RECOMMENDED SERVICE BULLETIN

NO. RSB 40-045

NO. RSB D4-033

The installation of a EMI-Filter on the ELT Remote Control Cable.

Drawing No. DA4-2560-00-00-SB

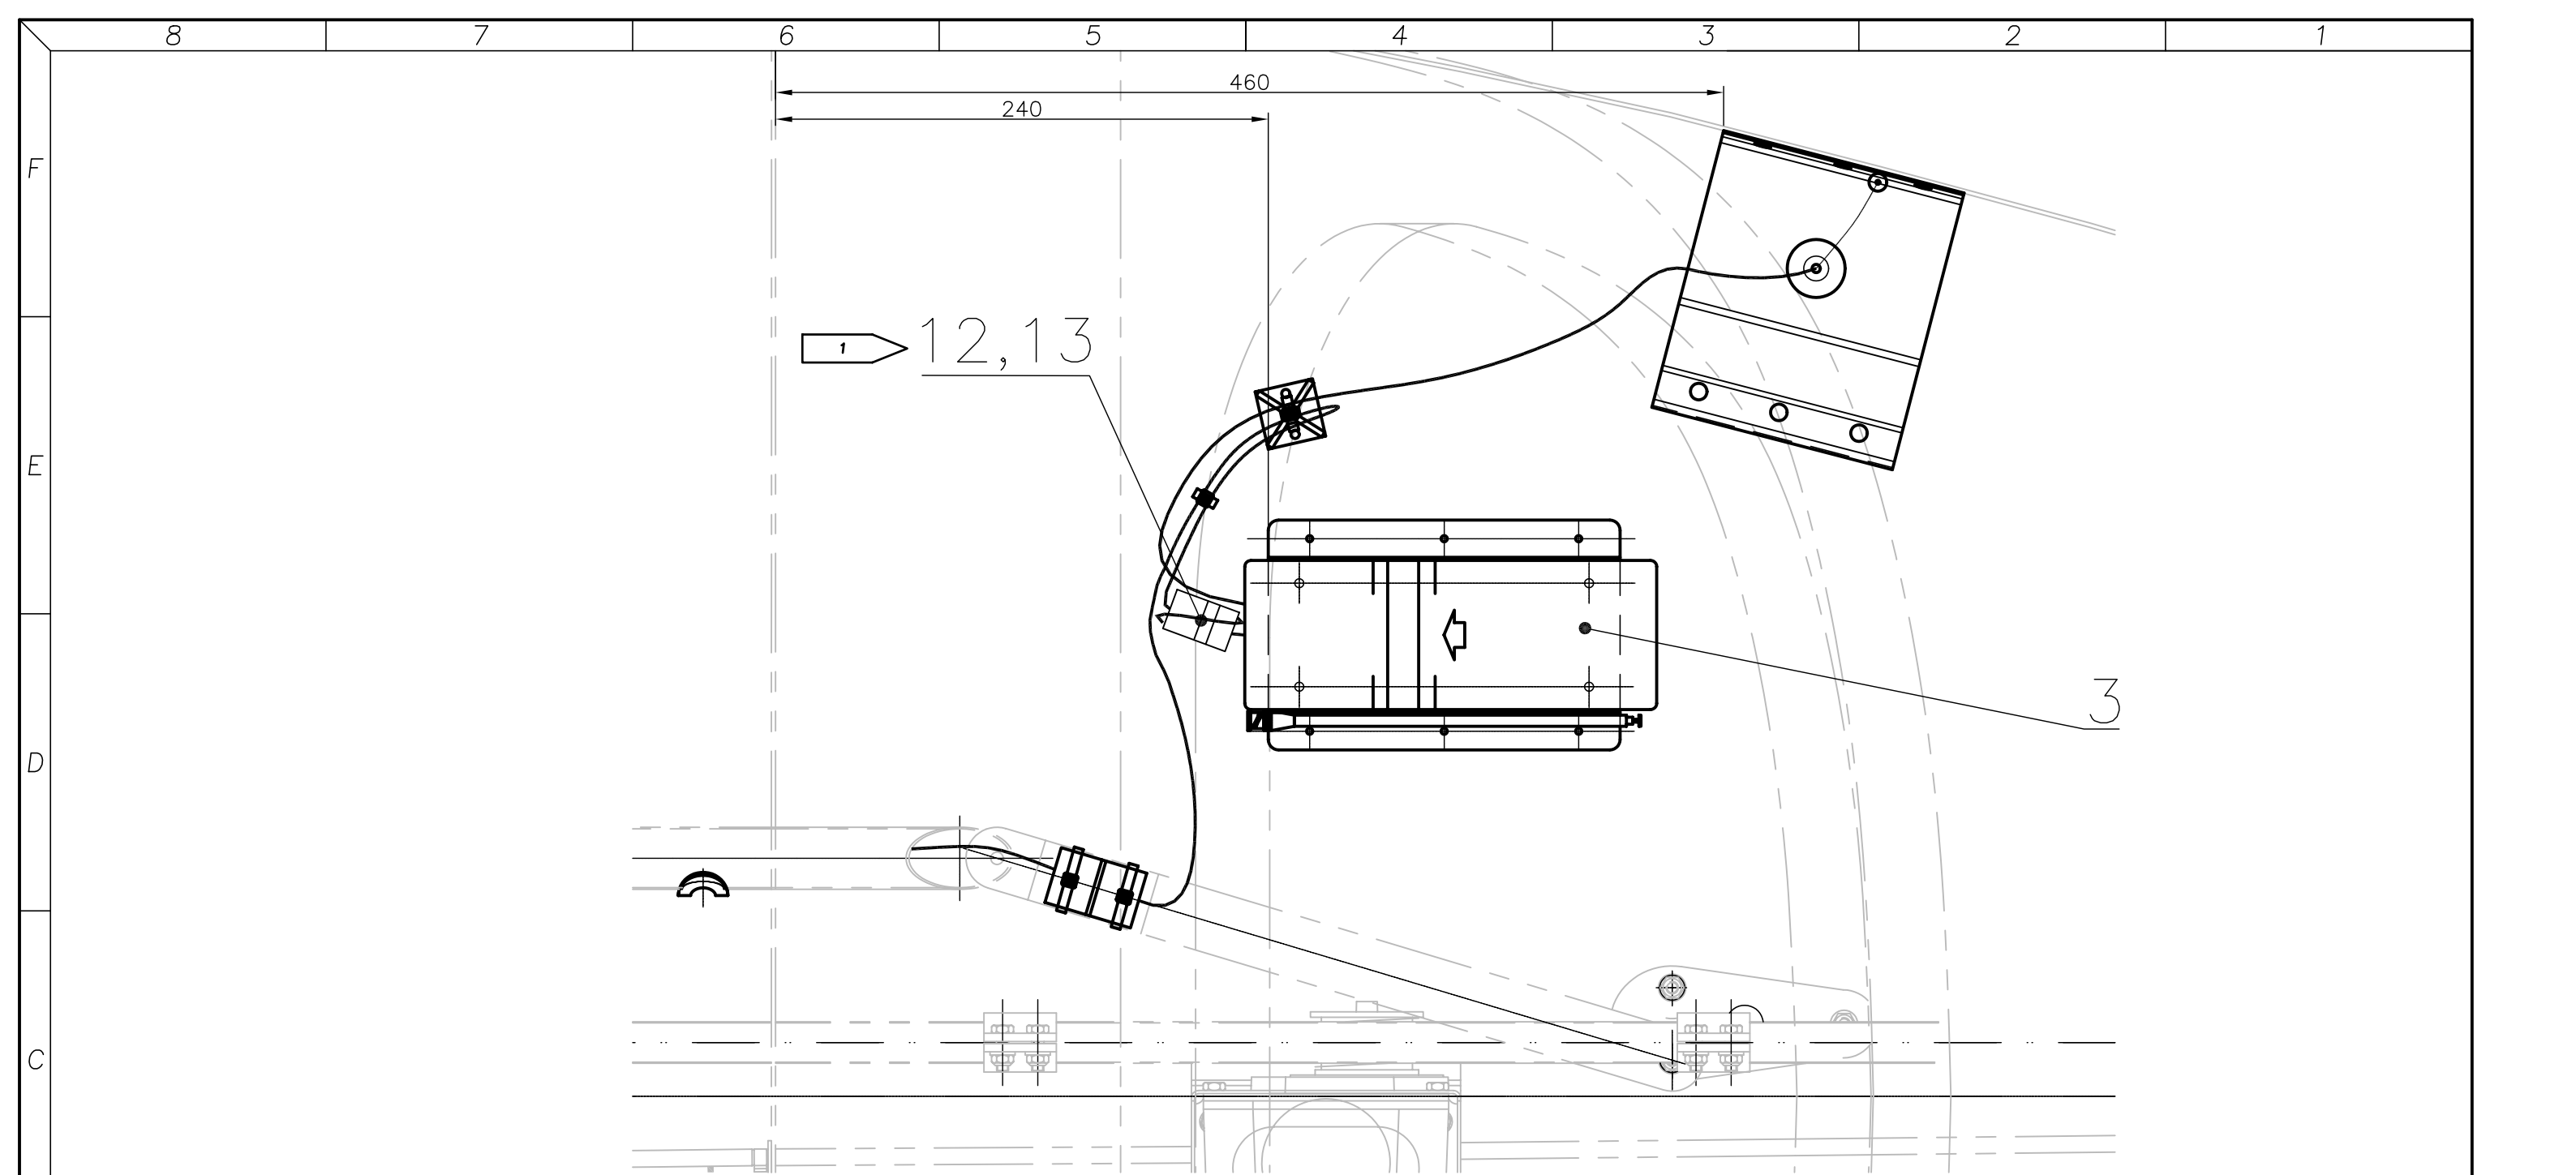
Some occurrences have become known in which the ACK-01 ELT has begun to send signals, triggered by normal use of the COM.

Investigations have shown that this is possible if the COM antenna cable and the ELT Remote Control Cable have been moved from the original position.

If such an occurrence happened, to avoid further unintentional triggering of the ACK-01 ELT a EMI-Filter can be installed on the ELT Remote Control Cable.

- Install EMI-Filter on ELT Remote Control Cable in accordance to drawing no. DA4-2560-00-00-SB

1 INSTALL FILTER AS CLOSE TO ELT UNIT AS POSSIBLE AND SECURE WITH TYRAP.
